### RFP# 2024-03 RTW BUILDING #3 ROOF REPLACEMENT

### ADDENDUM # 1 Date of Addendum: April 5th, 2024

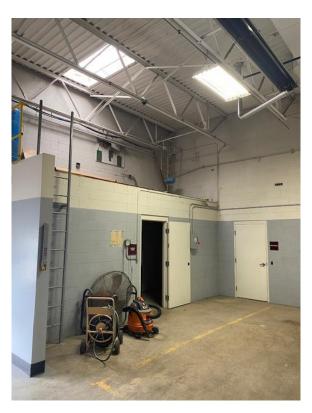
4. Roof Ladder Access is requested, where will the ladder be located?

Answer: Please see below photographs and location for a roof access ladder.
